UNITED STATES PATENT AND TRADEMARK OFFICE

APPLICATION NO.	FILING DATE	FIRST NAMED INVENTOR	ATTORNEY DOCKET NO.	CONFIRMATION NO.
10/060,300	02/01/2002	Takao Murakami	06753.0495	7085

Office Action Summary

*Regarding
1-5, 10
Claims*

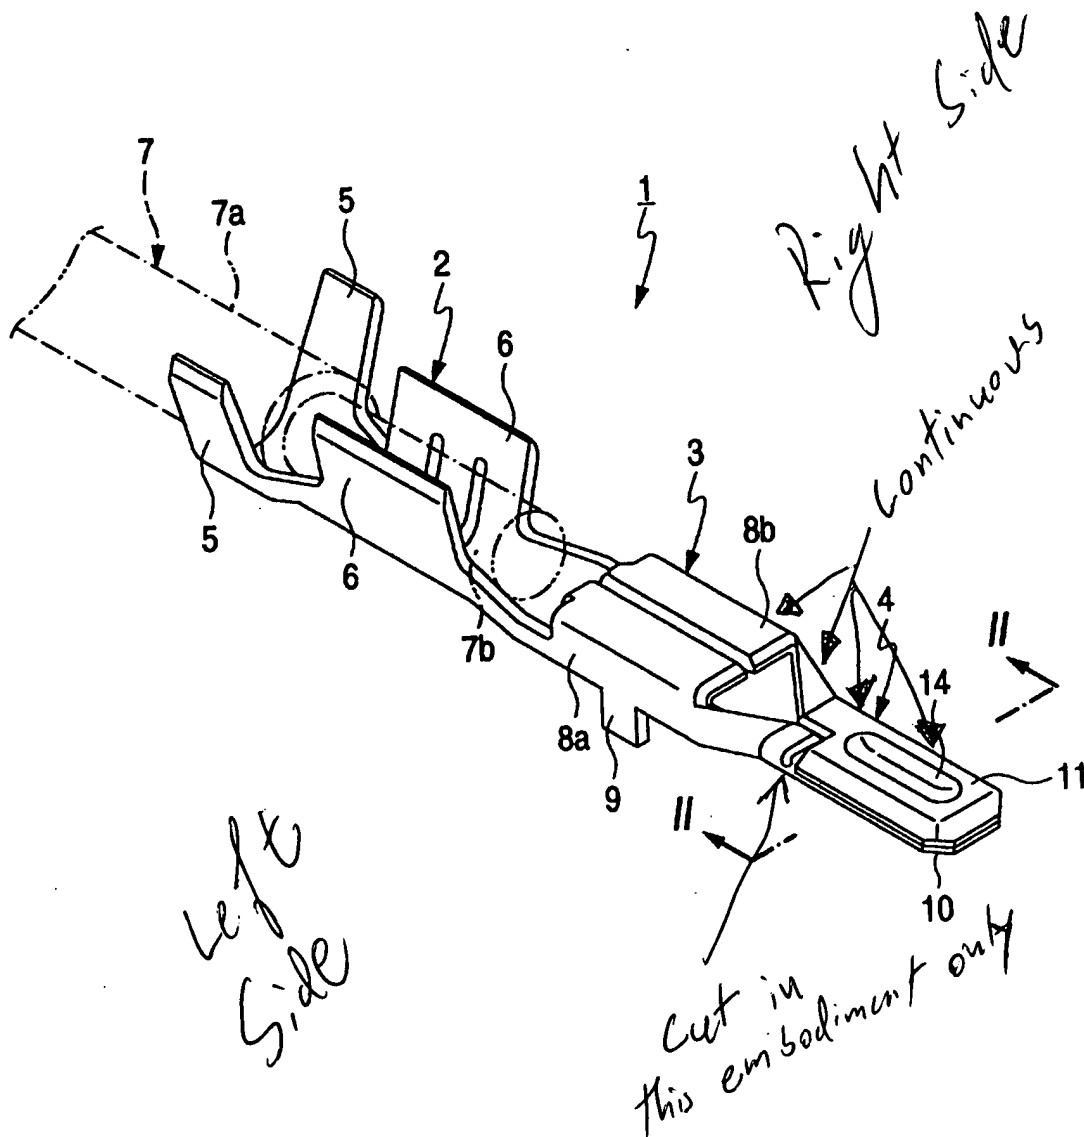
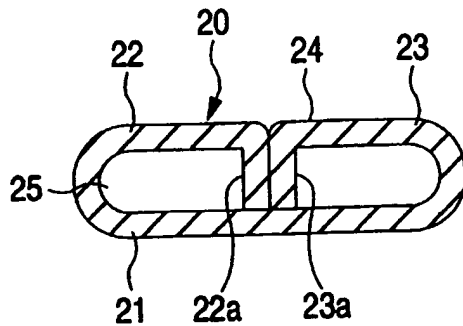
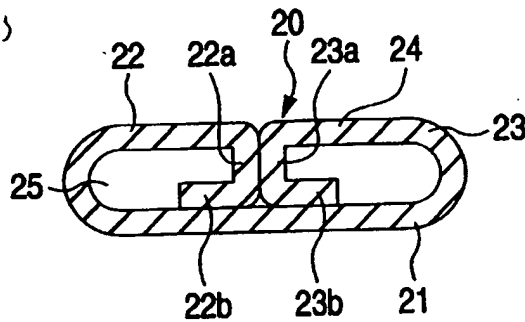
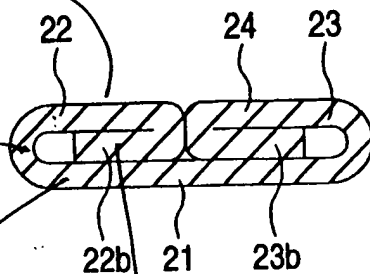
Claims 1-5, 10, 11, 13, 14, and 16 are rejected under 35 U.S.C. 102(b) as being anticipated by Fukuda et al. ("Fukuda"). Per claims 1, 10, 14, and 16, Fukuda discloses a male terminal fitting 1 comprising a plate-shaped contact protrusion 20 formed at one side of said male terminal fitting for mating with a female terminal fitting; and a conductor clamping portion located at the other side of said male terminal for clamping a conductor of an electric wire; wherein said plate-shaped contact protrusion includes a base plate component (see attachment) longitudinally extending from said conductor clamping portion in an elongated plate shape, an overlapping fold plate component laterally extending from one side of said base plate component and folded to overlap with said base plate component, and a flatness securing plate component overlapping with said base plate component and said overlapping fold plate component

Per claim 2, said overlapping fold plate component includes a side plate element (see attachment) upwardly extending from one side of said base plate component in a plane substantially perpendicular to said base plate component, and a top plate element extending from said side plate element in a plane substantially parallel to said base plate component; and wherein said flatness securing plate component overlaps said base plate component and said top plate element.

Regarding Fukuda, applicant argues that the base is not longitudinally extending from the clamping portion. The examiner disagrees. The base does extend from the clamping portion and the examiner does not agree with applicant's assertion that the identified base is only axially attached (see attachment). It is clear from the drawings that the "base" is continuous longitudinally with the clamping portion.
